Epping - Chatswood Tunnel Conversion

Reduction of operational flexibility

Submission by Matt Mushalik 17/11/2014 relating to:

Fig 1: Epping – Rous Hill is a branch line without network function for Western lines

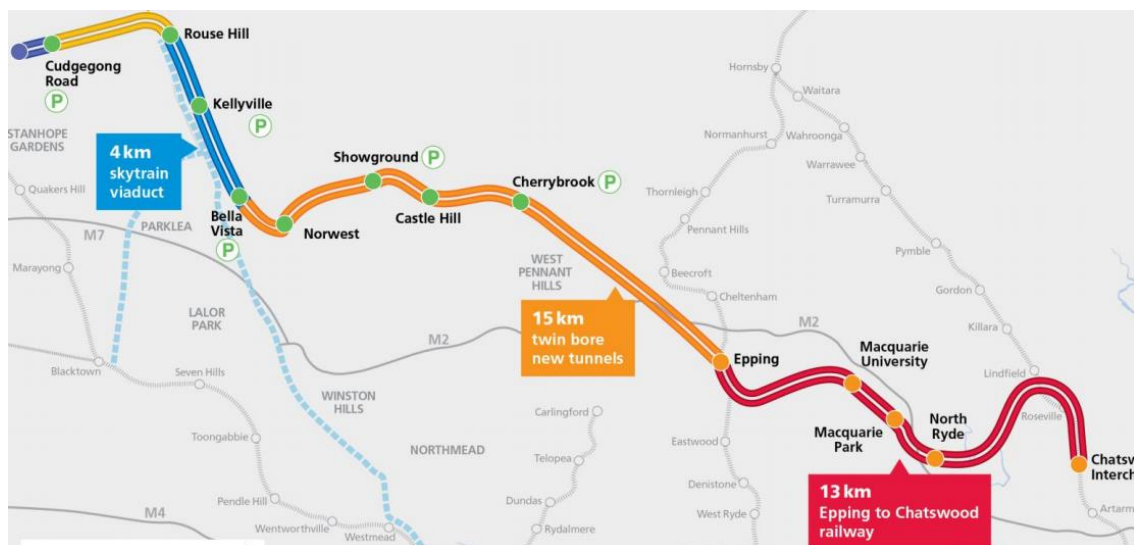
The objective of physical segregation of the existing Epping-Chatswood rail tunnel is an unnecessary self-mutilation because it is **reducing operational flexibility of the Northern part of Sydney's rail network**. It is bad enough that tunnel boring machines are drilling right now a new tunnel Epping – Rouse Hill which cannot accommodate double deckers. It is also politically wrong because if a private company is allowed to use publicly financed infrastructure it has to adapt its system to that existing infrastructure and not the other way around.

Fig 3: Location of dive structures and stub tunnels

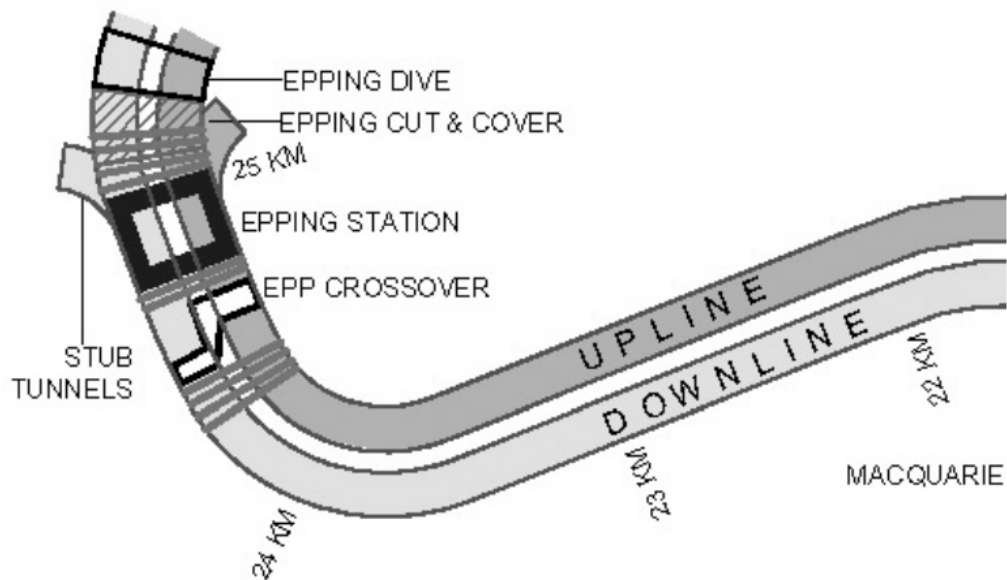
<http://www.asa.transport.nsw.gov.au/sites/default/files/asa/railcorp-legacy/disciplines/civil/tmc-132.pdf> The EPP crossover should not be removed

Fig 4: Areal view of dive structures at Epping station

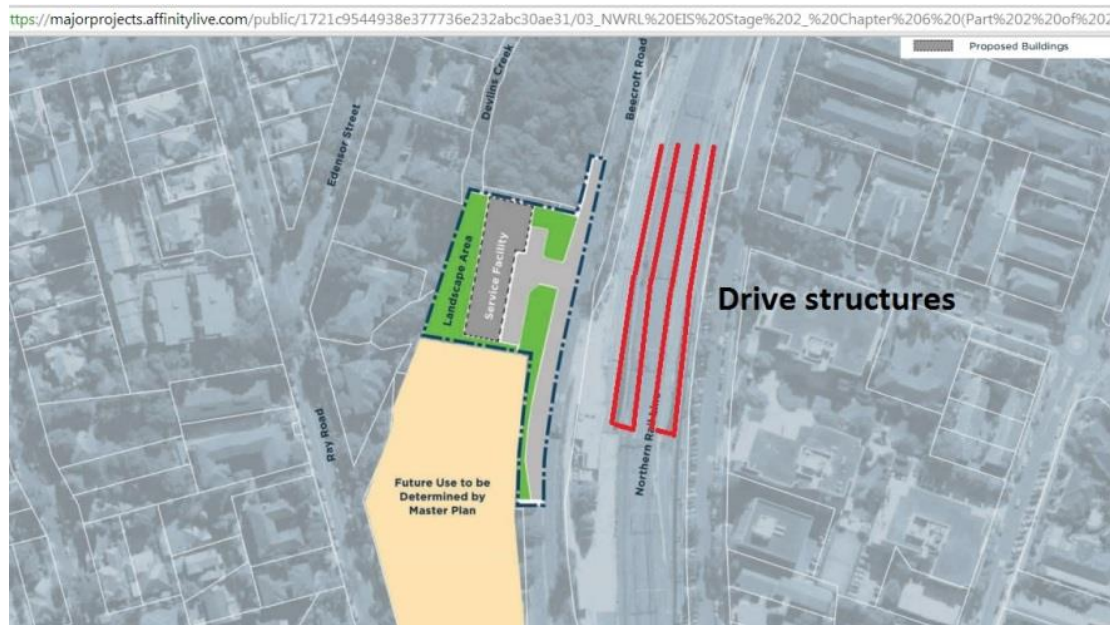
(b) and (c) means a reduction in operational flexibility. This is unacceptable. Imagine the rail line Epping – Strathfield is interrupted by fallen trees in one of the ever increasing storms under global warming conditions. Then you lose the freedom to move double deckers through the Epping – Chatswood tunnel

(b) means that the tunnel cannot be accessed in emergencies by e.g. diesel powered rescue vehicles from Hornsby. Let us assume a breakdown of a train in the Chatswood – Epping tunnel. How will that be pulled out? The whole tunnel up to Currajong would have to be emptied to do that. The principle is that you have as many rail based access points to a tunnel as possible.

Provided the tracks in the dive structure remain in place (b) and (c) can be reversed at modest cost if that is later required. It is not clear why points have to be removed as there are very simple means to stop points from operating in an undesired direction.
